CODE CHANGE PROPOSAL FORM

Model Code: [2024 IRC](#)

Code or Rule Section:
[2024 IRC Section 325](#)

Firm/Association affiliation, if any: [Stator LLC, Representing the Home Ventilating Institute \(HVI\)](#)

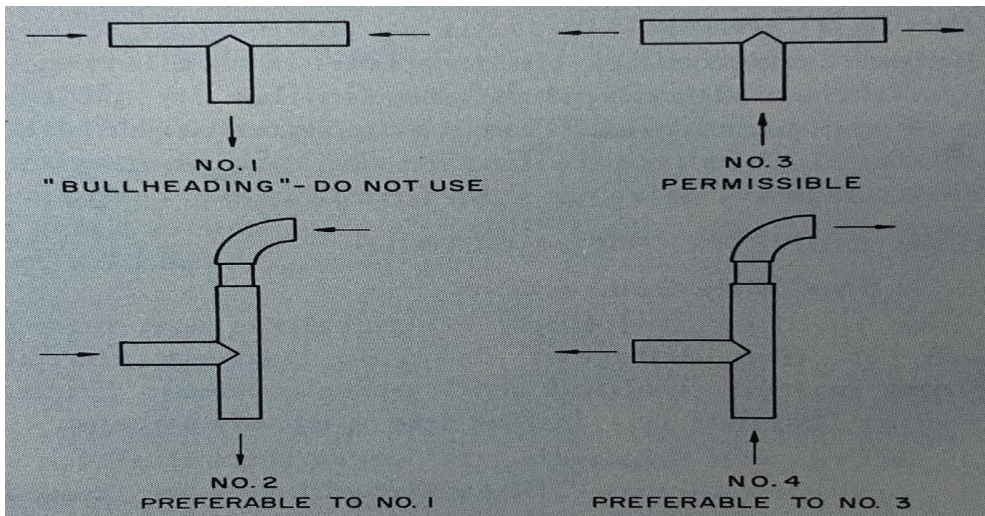
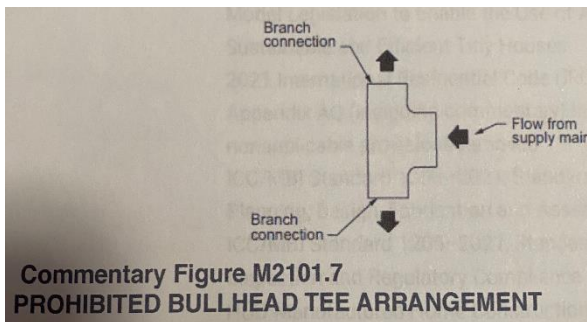
1. Why is the proposed code change needed? Please provide a general explanation as well as a specific explanation for any changes to numerical values (heights, area, etc.)

In the Carrier book "Handbook of Air Conditioning System Design", there is "Tees should be installed to prevent "bullheading" as illustrated in Fig. 5. "Bullheading" causes turbulence which adds greatly to the pressure drop and may also introduce hammering in the line." Note that they state "returning through the branch connection" is not acceptable, whereas supplying through the branch connection is acceptable.

Section 23 21 13 Hydronic Piping, Installation 3.1H (underline added): “Tee water piping run outs or branches into the side of mains or other branches. Avoid bull-head tees, which are two return lines entering opposite ends of a tee and exiting out the common side.”

This prohibits the branch connection being a return connection.

IC Commentary Figure M2101.7 depicts a prohibited “bullhead” tee arrangement. Installation of such a connection creates excessive pressure drop, poor system performance and possible cavitation (air bubbles) that cause erosion of metal pipes. Supply side flow must not enter a tee from the branch opening. This section does not apply to tees in return piping arrangement because the flow entering a tee branch opening merges with the unidirectional flow in the run of the tee.

Add new language:

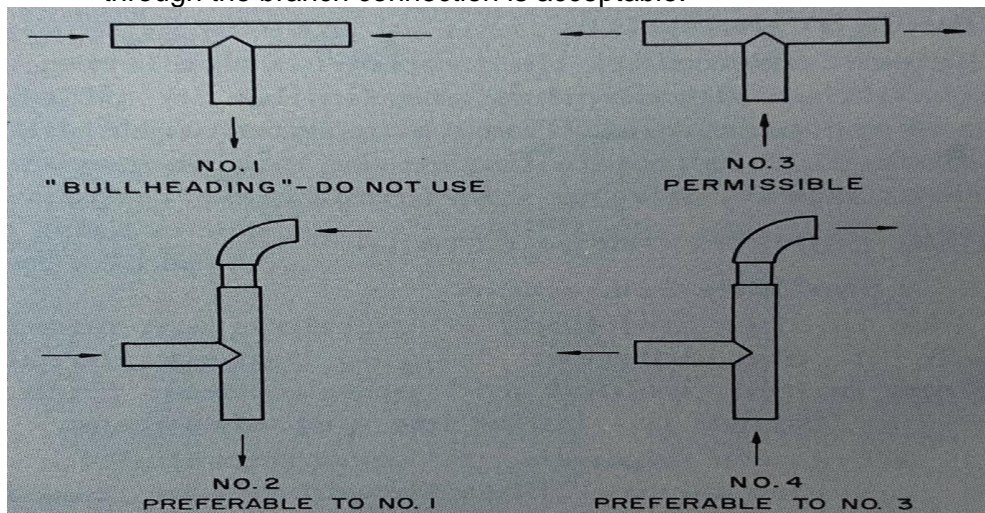
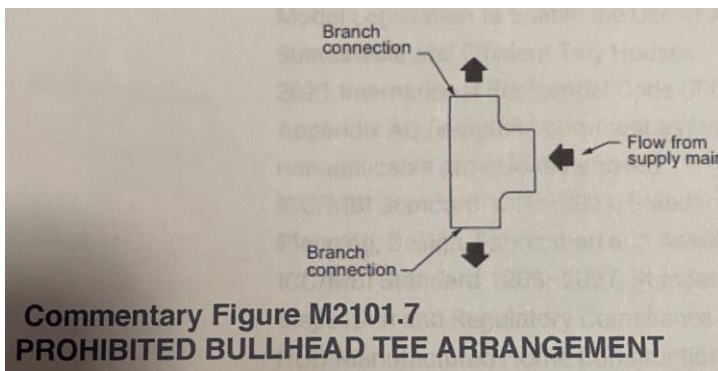
1. Why is the proposed code change needed? Please provide a general explanation as well as a specific explanation for any changes to numerical values (heights, area, etc.)

In the Carrier book “Handbook of Air Conditioning System Design”, there is “Tees should be installed to prevent “bullheading” as illustrated in Fig. 5. “Bullheading” causes turbulence which adds greatly to the pressure drop and may also introduce hammering in the line.” Note that they state “returning through the branch connection” is not acceptable, whereas supplying through the branch connection is acceptable.

Section 23 21 13 Hydronic Piping, Installation 3.1H (underline added): “Tee water piping run outs or branches into the side of mains or other branches. Avoid bull-head tees, which are two return lines entering opposite ends of a tee and exiting out the common side.”

This prohibits the branch connection being a return connection.

IC Commentary Figure M2101.7 depicts a prohibited “bullhead” tee arrangement. Installation of such a connection creates excessive pressure drop, poor system performance and possible cavitation (air bubbles) that cause erosion of metal pipes. Supply side flow must not enter a tee from the branch opening. This section does not apply to tees in return piping arrangement because the flow entering a tee branch opening merges with the unidirectional flow in the run of the tee.

M2101.7 Prohibited tee applications. ~~Fluid in the supply side of a hydronic system shall not enter a tee fitting through the branch opening.~~ A bullhead tee is one in which the branch connection is larger than the straight through run connections. Supply flow into the branch connection or return through the branch connection of a tee fitting shall be avoided where possible and must be a bullhead tee fitting where used. Use of a bullhead tee of either arrangement shall not be permitted immediately before or after boilers, chillers or associated pumps.
